Placer County Office of Education

Office Building Tenant Improvements, Annex Building Alterations, & Site Improvements @ Various Sites

ADDENDUM NO. 2

Friday, September 1, 2023

1 E2.05 — SECOND FLOOR PARTIAL PLAN - REMODEL - WEST - LIGHTING

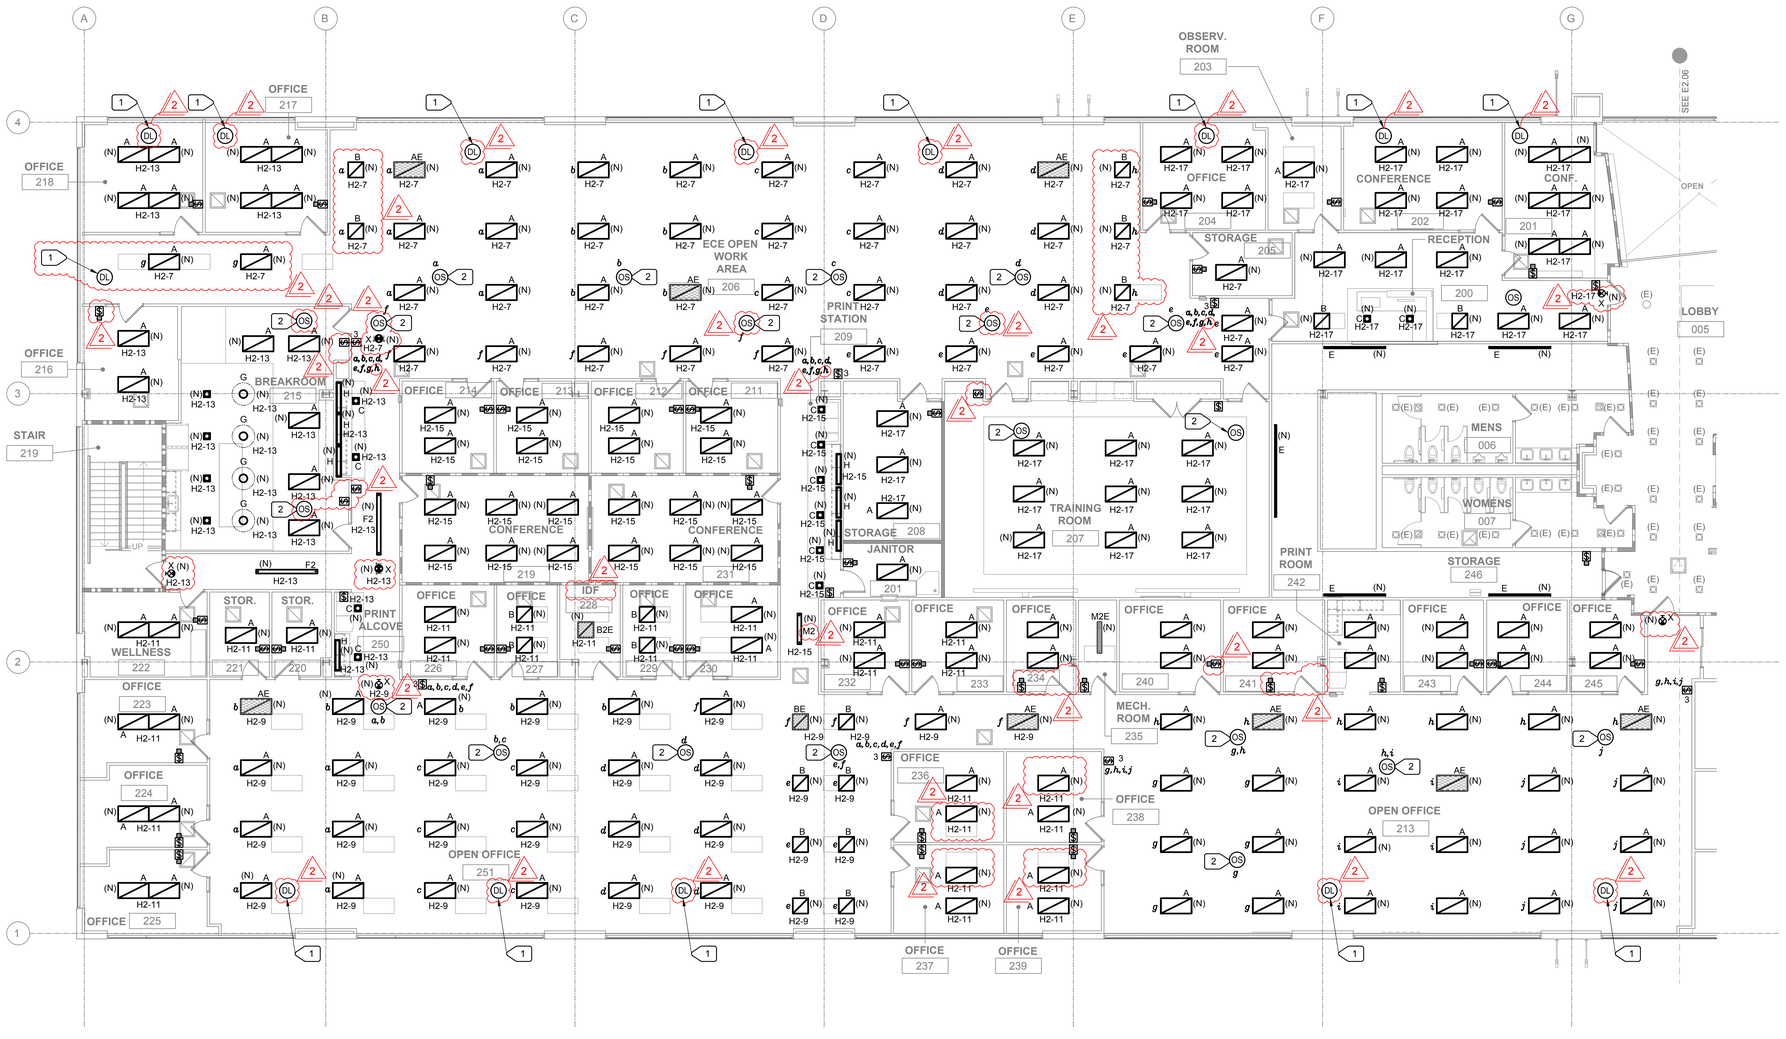
A. **REVISED** extent of new lighting. **See attached 'SHEET E2.05'.**

1 E3.01 — FIRST FLOOR PARTIAL PLAN - DEMOLITION - WEST - ELECTRICAL

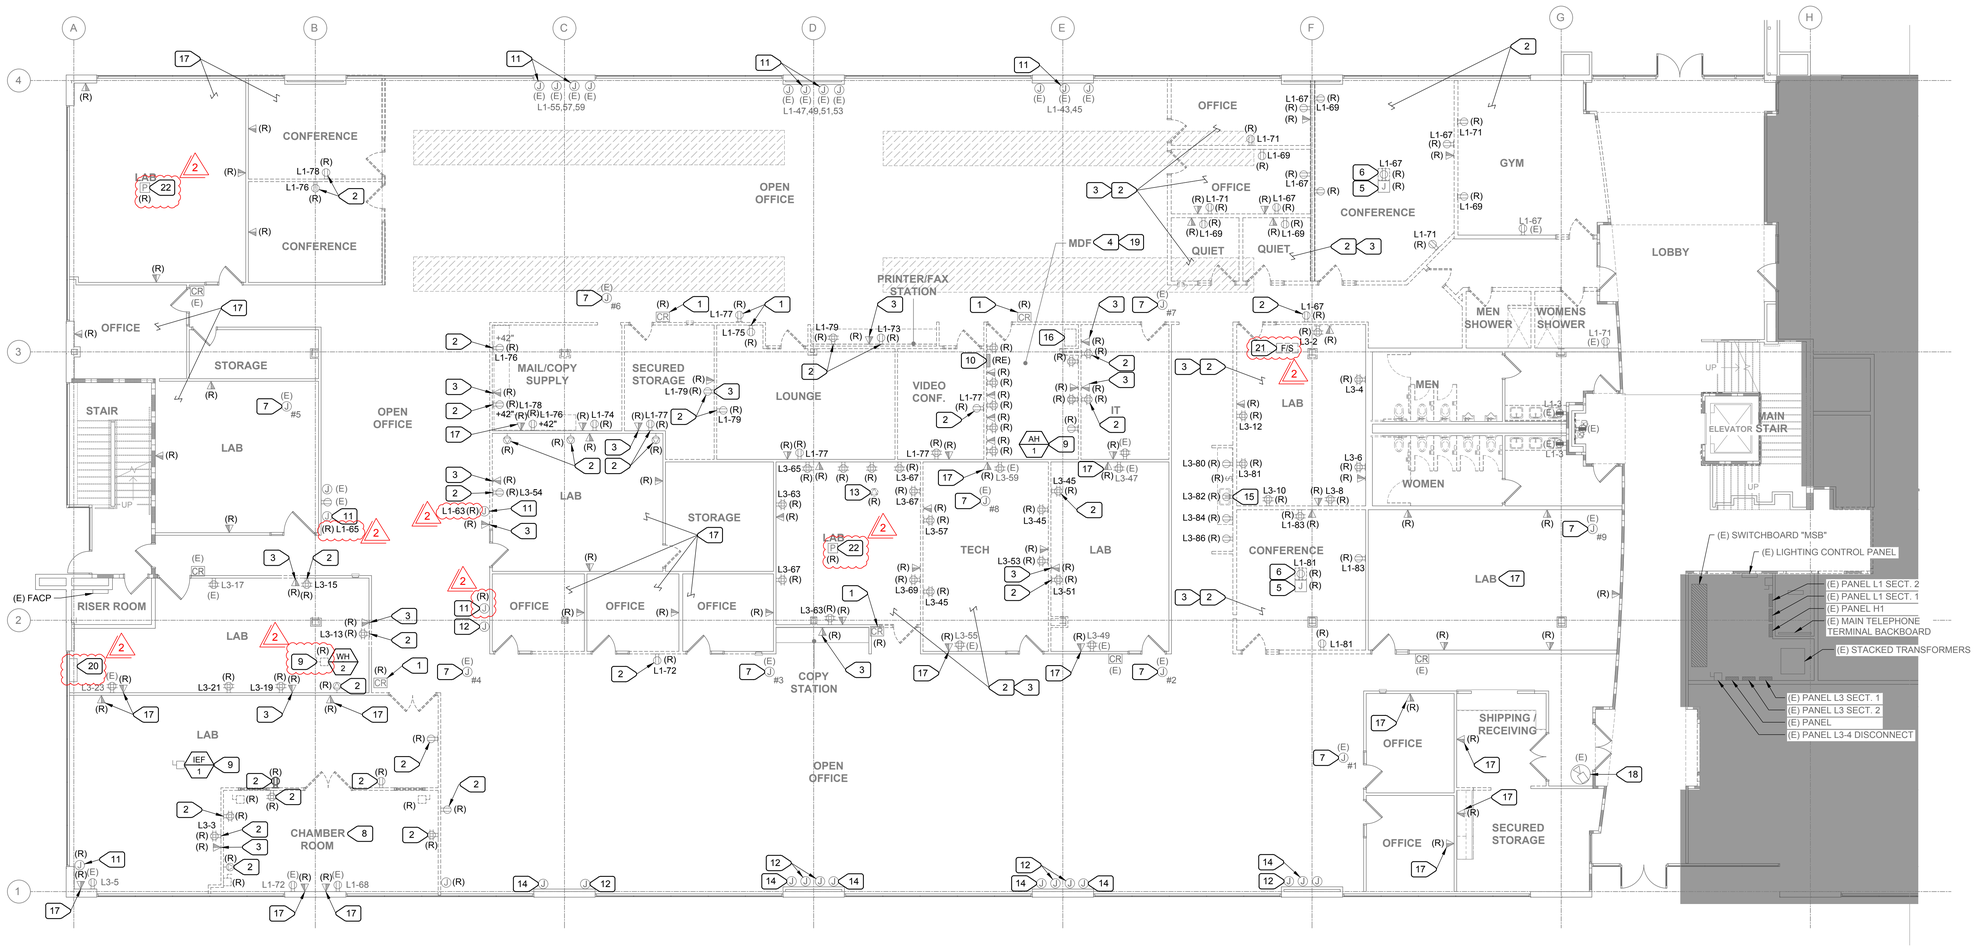
A. **REVISED** extent of electrical demo. **See attached 'SHEET E3.01.**

1 E3.02 SECOND FLOOR PARTIAL PLAN - DEMOLITION - WEST - ELECTRICAL

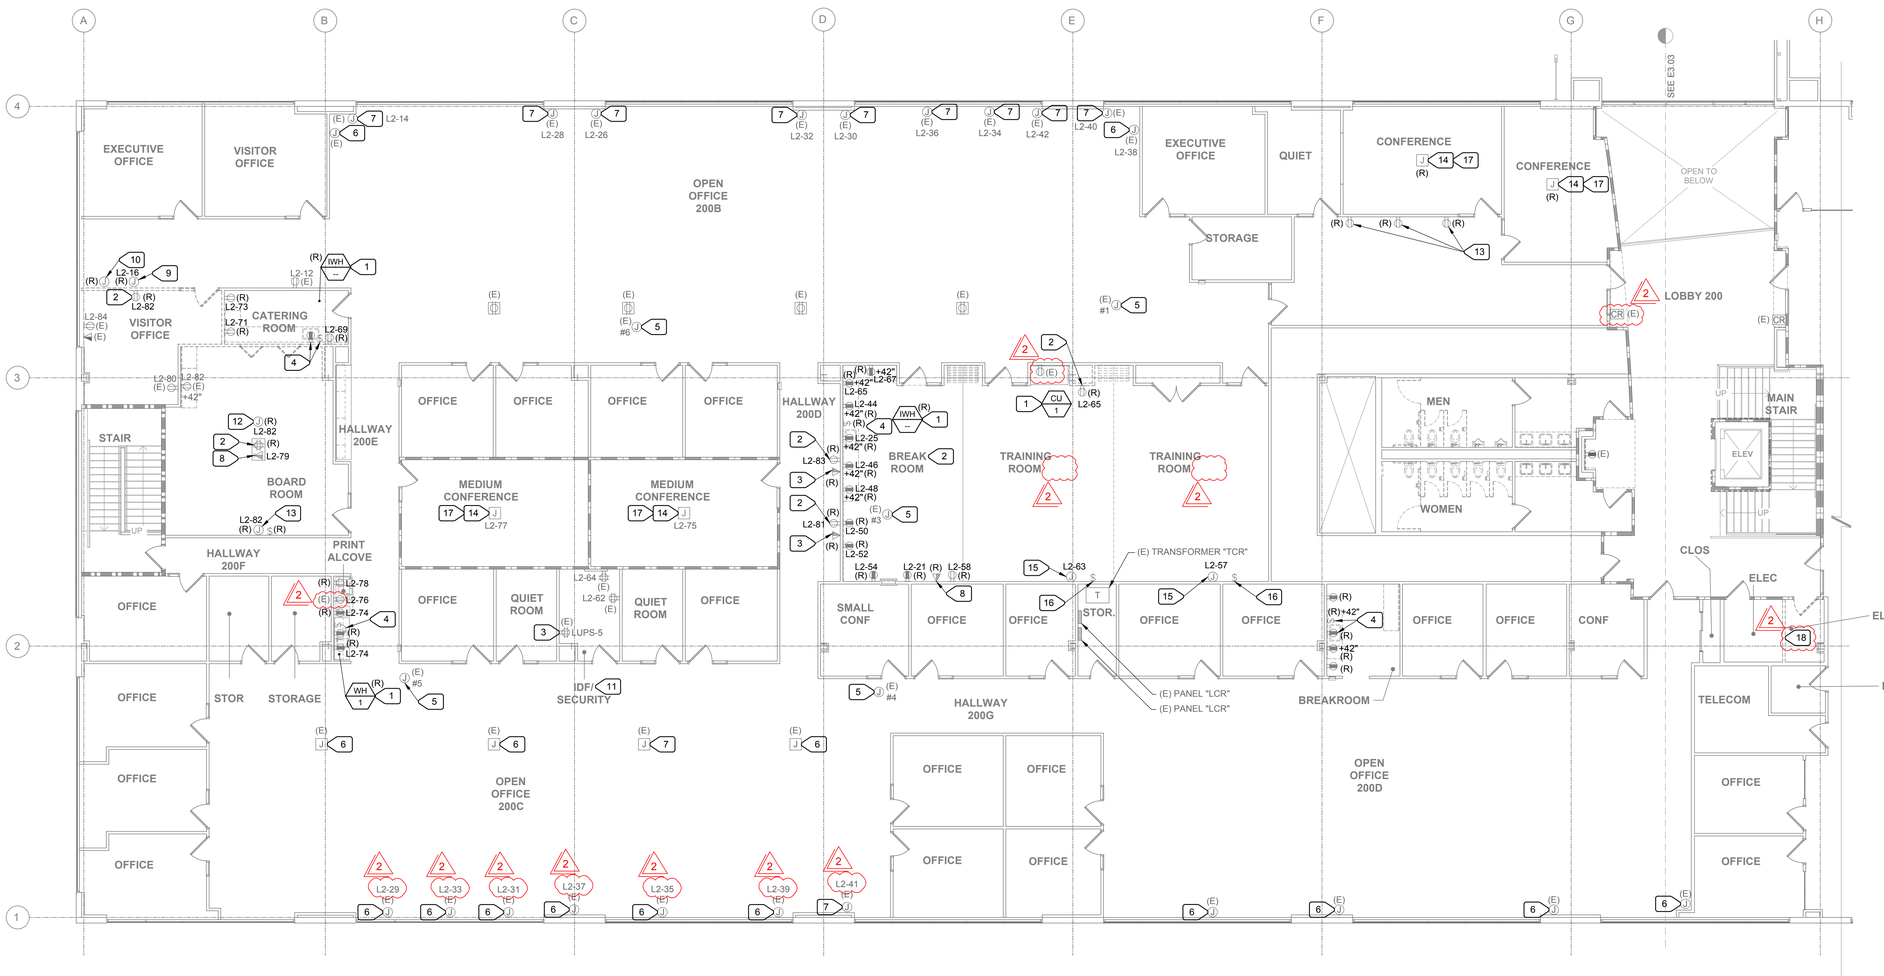
A. **REVISED** extent of electrical demo. **See attached 'SHEET E3.02'.**

1 / E3.04 FIRST FLOOR PARTIAL PLAN - REMODEL - WEST - ELECTRICAL

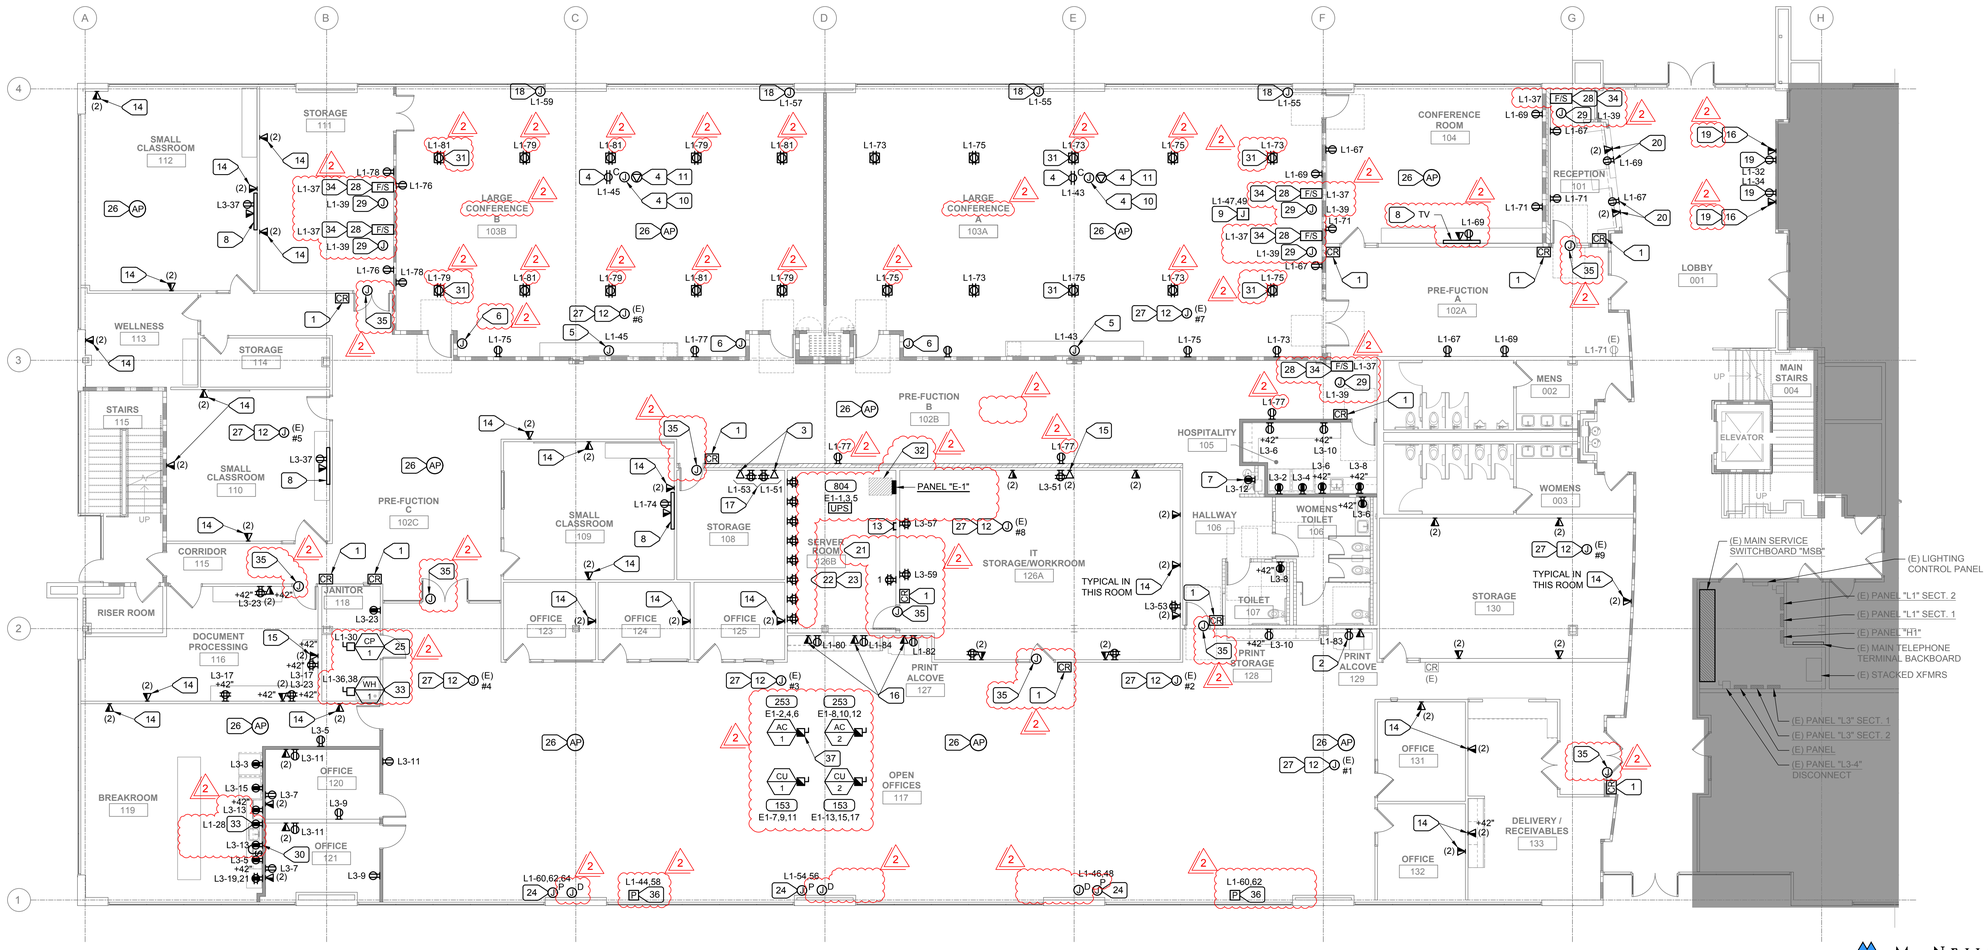
13. *New Main Office: E3.04/E3.05 Can you please clarify what the following symbol is indicative of? This symbol is not noted in the electrical sheet index. It is currently assumed that this is just a pathway only for future cabling by wanted to clarify.*

14. *New Main Office: E3.04/E3.05 Can you please clarify what the following symbol is indicative of? With no number in the parentheses, we are assuming that this is only indicative of a 4-11/16" box for data outlet, and there will not be a cable pulled to these locations, but we wanted to clarify.*

1 / E3.05 SECOND FLOOR PARTIAL PLAN - REMODEL - WEST - ELECTRICAL

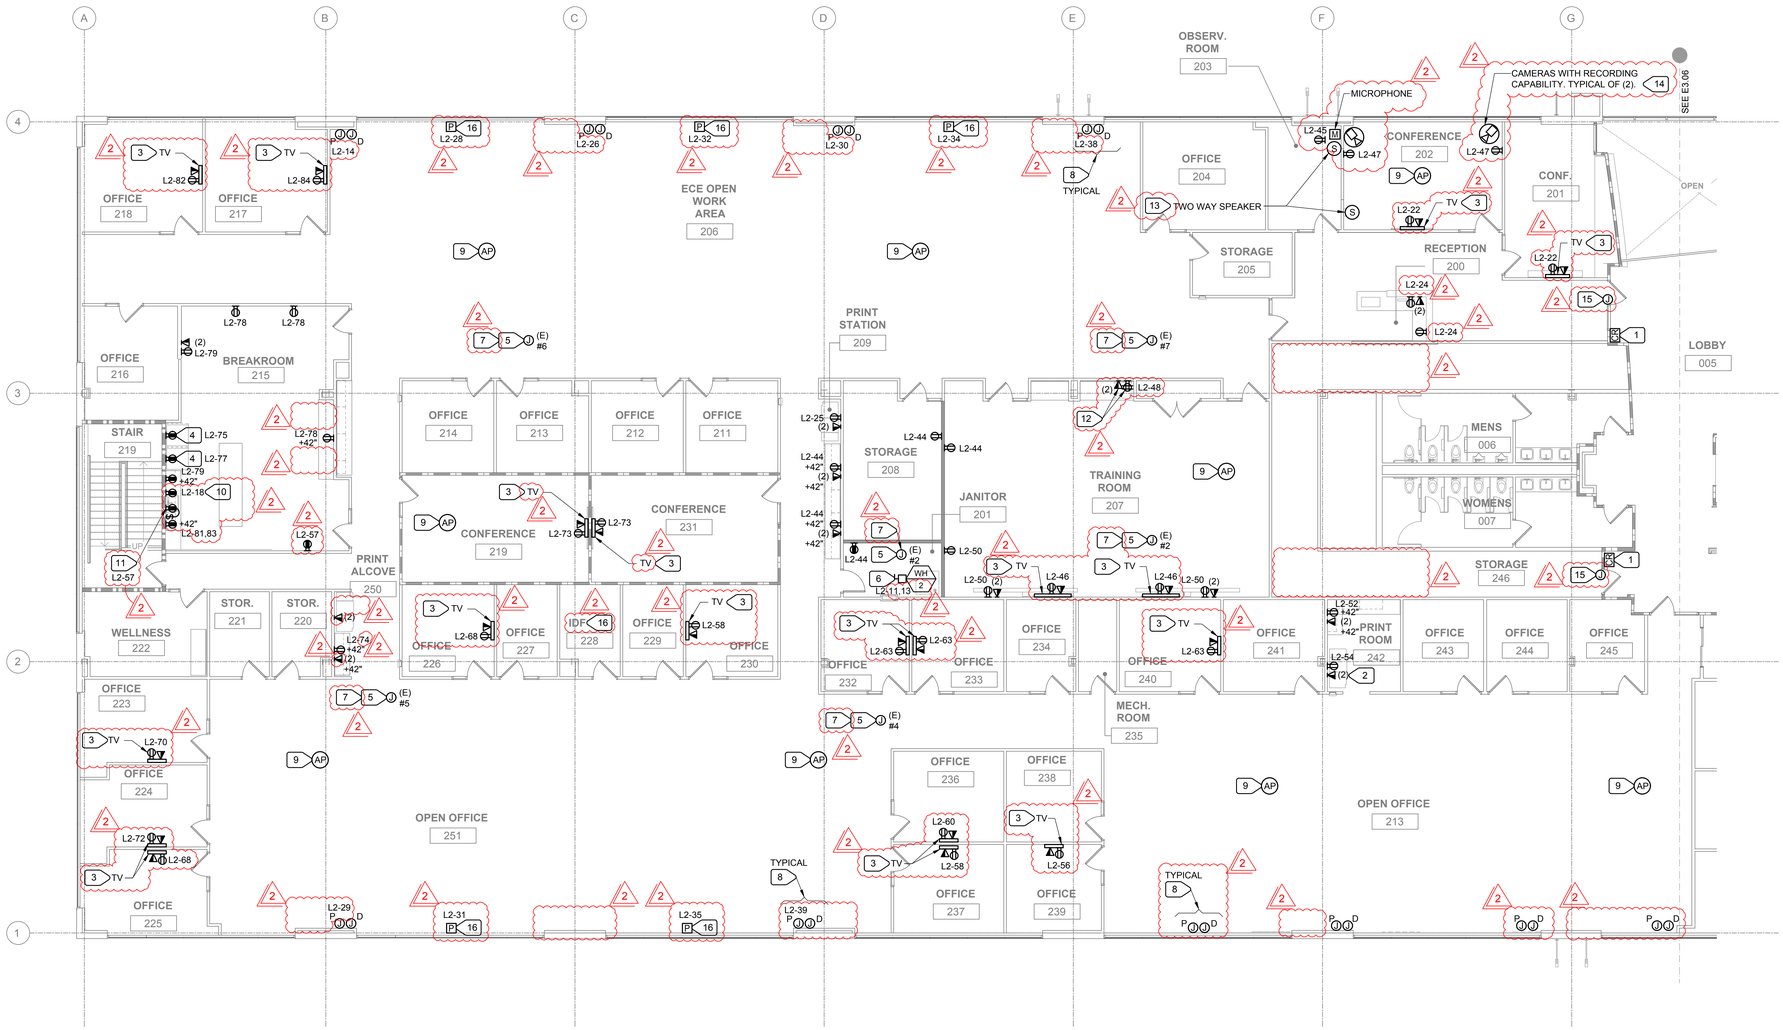
15. *New Main Office: E3.05 Please clarify if the following junction box locations noted below call out for a data cable to be pulled or if they are just meant for a future pathway location.*

1 / E3.06 SECOND FLOOR PARTIAL PLAN - REMODEL - EAST - ELECTRICAL

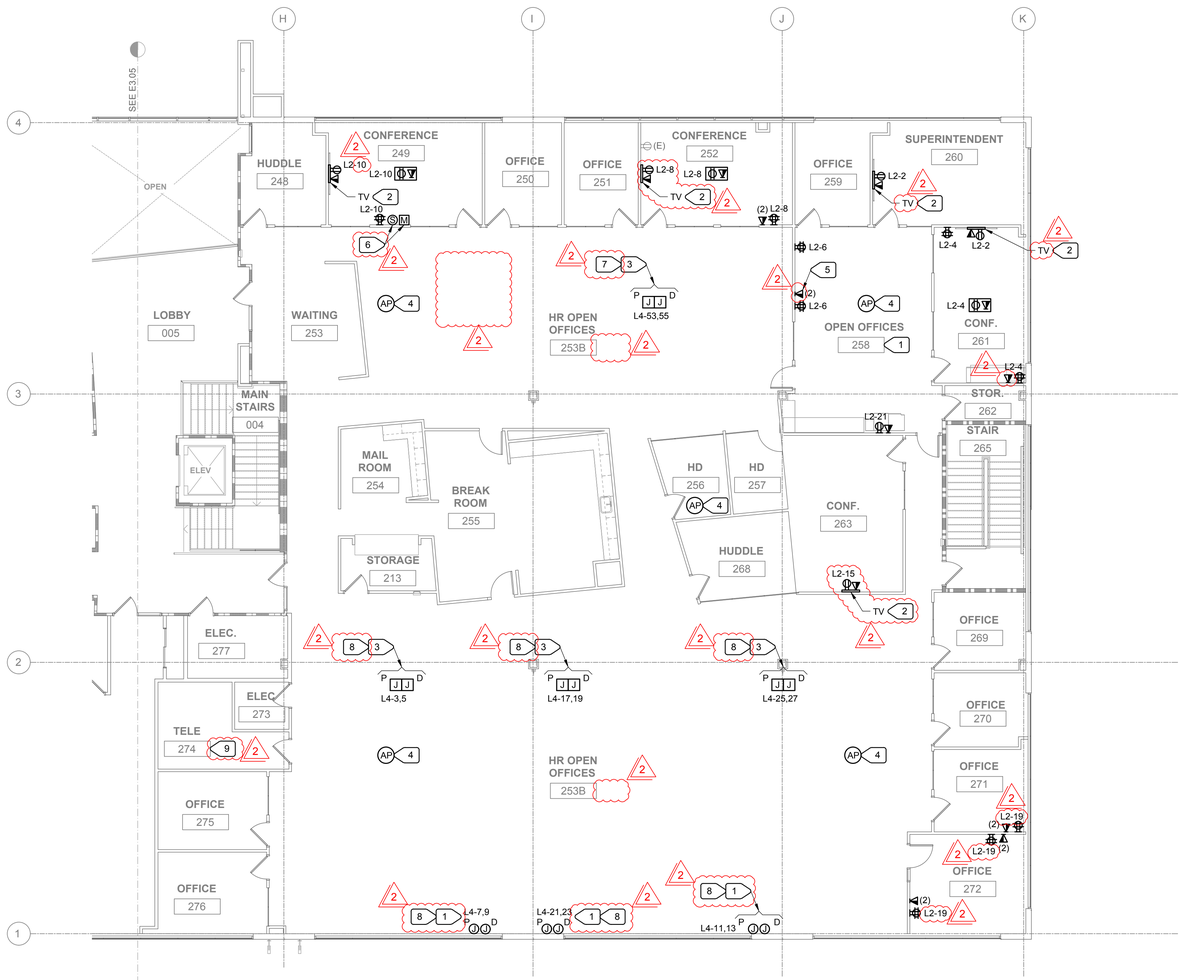
A. **REVISED** extent of new electrical. **See attached 'SHEET E3.06'.**
